REVISED RESPONSE TO REQUEST FOR ADDITIONAL INFORMATION

APR1400 Design Certification

Docket No. 52-046

RAI No.: 199-8223
SRP Section: 03.08.01 - Concrete Containment
Application Section: 03.08.01
Date of RAI Issue: 09/08/2015

Figure 3.8-26 Code Jurisdiction Boundary of Common Basemat

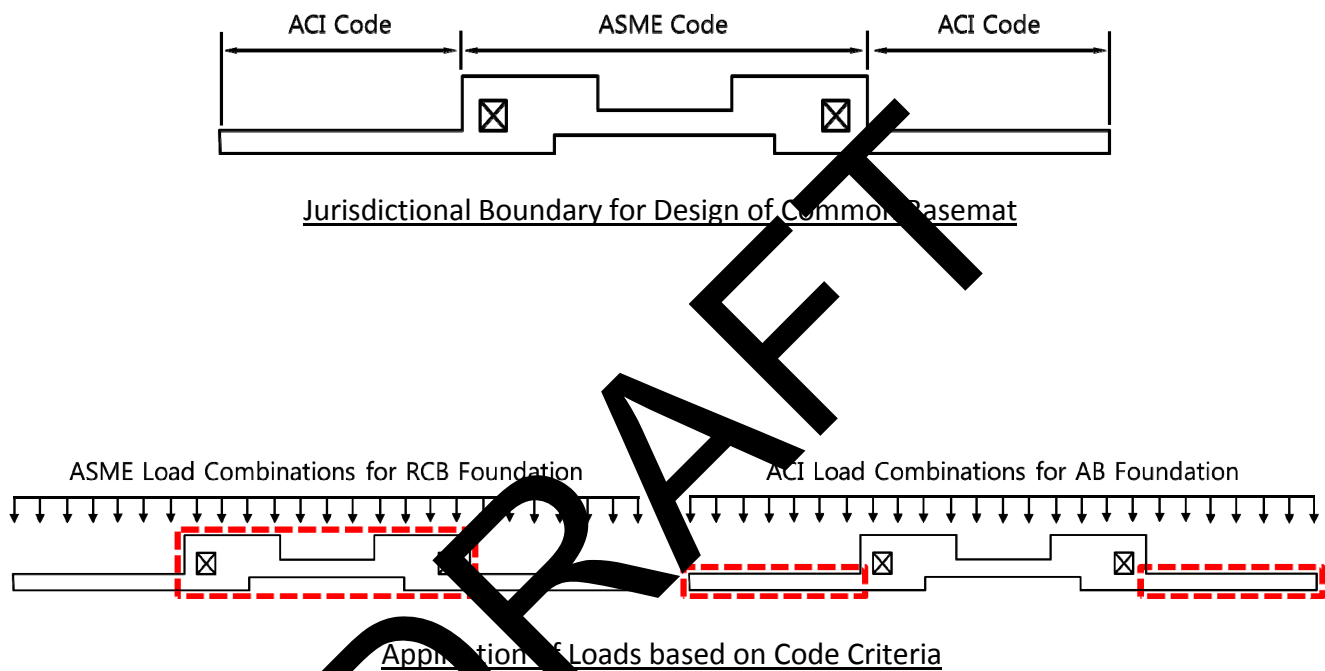
The containment structure, including the basemat directly beneath the containment is integral with the auxiliary building (AB) basemat. The staff noted that Section 3.8.1 of the DCD Tier 2 does not describe the jurisdictional boundary for design of the containment in accordance with ASME Section III, Division 2, Subsection CC. In accordance with Appendix A to 10 CFR Part 50, General Design Criteria 1, 2, 4, 16 and 50, and SRP 3.8.1, the applicant is requested to identify the jurisdictional boundary of the containment for design in accordance with ASME Section III, Division 2 Code, and describe what aspects of the design incorporates additional design requirements beyond the portion of the containment foundation directly beneath containment shell. In addition, the applicant is requested to update Section 3.8.1 of the DCD Tier 2 accordingly.

The design basis of the NI common basemat under the RCB and the AB conform to the requirement of ASME Section III, Division 2, Subsection CC and ACI 349, respectively. The boundary of jurisdiction between the ASME and the ACI codes is shown in Figure 3.8-26. The jurisdictional boundary is placed at the thickness transition interface due to the physical configuration and functional requirements of the basemat. The anchoring of the containment shell reinforcement is limited within the ASME code boundary as shown in Figures 3.8A-16 and 3.8A-17.

As the design criteria for the two portions of the basemat are different, the application of loads is also divided into two parts, as shown in Figure 3.8-26. The load combinations provided by the ASME and the ACI codes are used in the analysis and design of the RCB and AB foundations, respectively. At the interface between the ASME and ACI codes, a greater amount of reinforcement required by either code is used, and the reinforcement of the RCB foundation is developed into the AB foundation as shown in Figures 3.8A-16 and 3.8A-17. The provisions of both codes are used to select a conservative development length. The portion beyond the RCB foundation, i.e., the entire AB foundation area, is conservatively designed using the larger member forces from the analysis results of the ASME and ACI codes.

Figure Added
